Engine Fuel Filters
CHU, CLX, CMH, CMM, CSM, CXU, CXX,
GU, LEU, LR, MRU, TD

FSB 233-006, Engine Fuel Filters

(March 2016)

Week Number Date Code

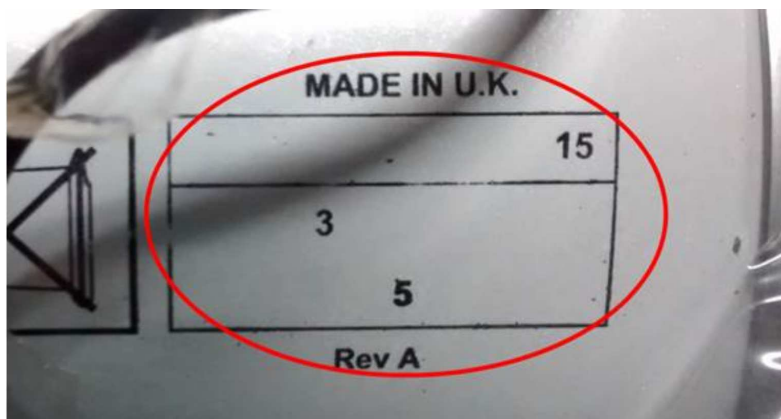
Engine fuel filters (part number 21380521) with week number date codes "15_33" (August 10, 2015) through "15_39" (September 27, 2015) should not be installed on an engine without first being inspected. The week number date code is marked on the outside of the filter, the number on top is the year and the number below identifies the week. Due to a manufacturing issue, fuel does not flow through the filter which results in a no-start/run condition immediately after installation.

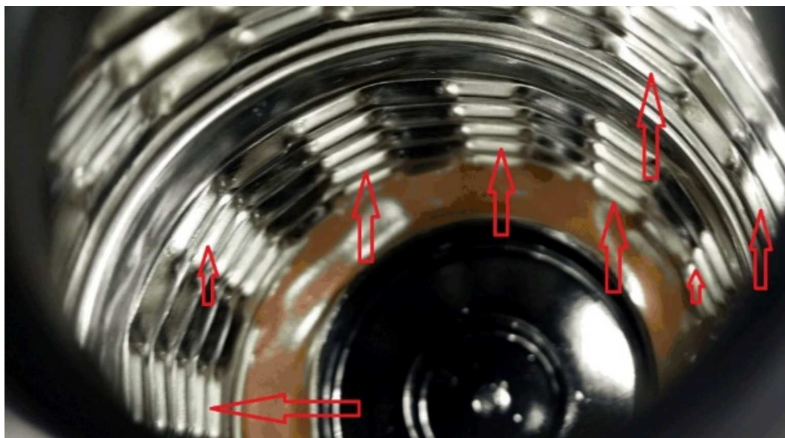
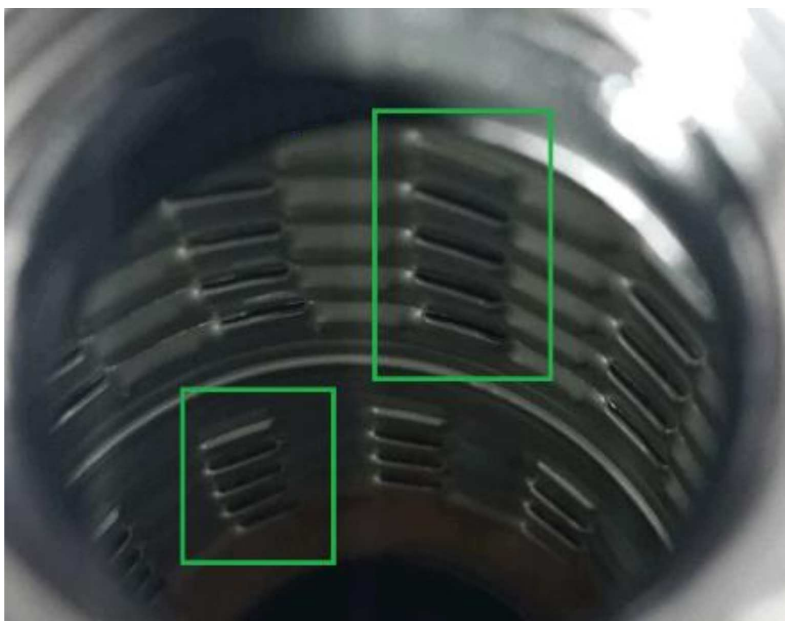
To determine if a filter can be installed on an engine, shine a flash light inside the filter to verify the holes/slits are present for fuel flow.

Unusable Filter

Usable Filter
